# Access Compliance Report

## Public Rights-of-Way

### (Curb Ramps)

| Intersection ID: 14356 | Main Street: BAXTER_ST | Cross Street: S_TORRENCE_ST | Location: W            |

| ADA ID: 5130CE12257F   | Ramp Type: Perp        | Initial Pass/Fail: Fail     | Overall Compliance: No |

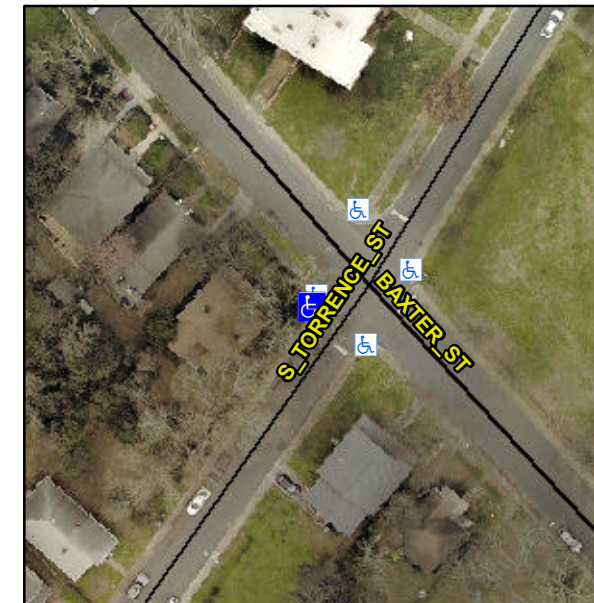
**R304.2.2**

| Compliance | Description           | Data  | Compliance | Description                 | Data |
|------------|-----------------------|-------|------------|-----------------------------|------|
| N/A        | Ramp Length (in)      | 48.0  | No         | Ramp Slope (%)              | 13.6 |

**Remove & Replace Entire Ramp.**
